ROOF INSPECTION REPORT

Building located at Old Manchester Road * Raymond, NH
Building used for Elementary School
Owners identification of area or building # Lamprey River Elementary School * Built in 1976
Exterior wall construction: Masonry Wood Steel Other

Dear Mr. Beloin, Ref: Lamprey River Elementary School roof project

RE: LAMPREY RIVER ELEMENTARY SCHOOL

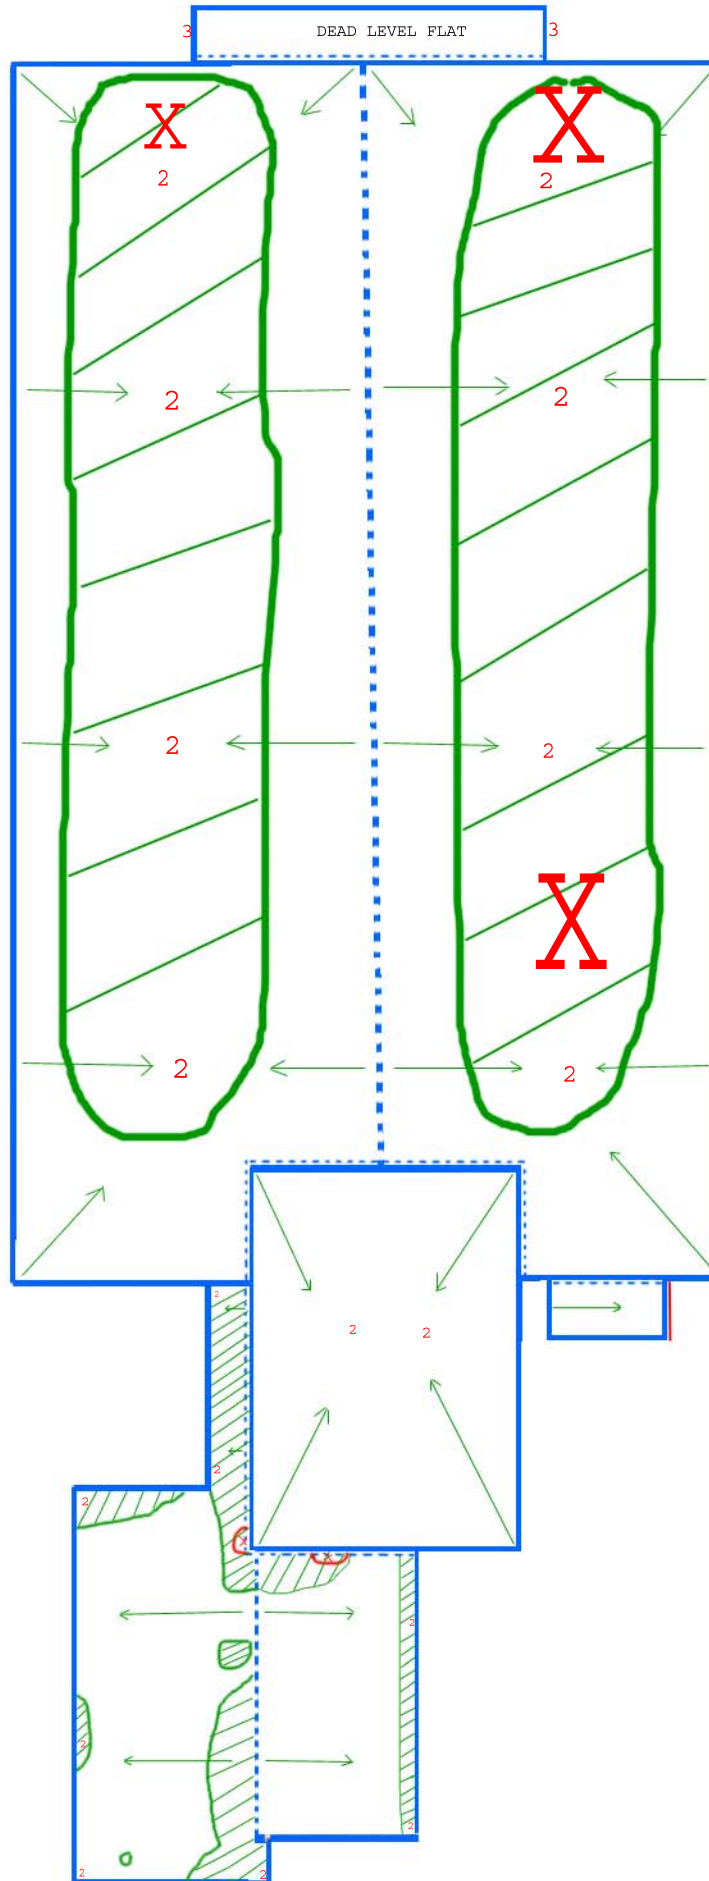
There are clearly 3 roofs on the Lamprey river Elementary School. Two built-up roofs and one thin membrane roof. With the flood coating and stones, the 2 built-up roofs are over 2 inches thick. Add the 2 inches of wood fiber insulation not included in this sample and you have +or- 6 inches of roof on the Lamprey River Elementary School.
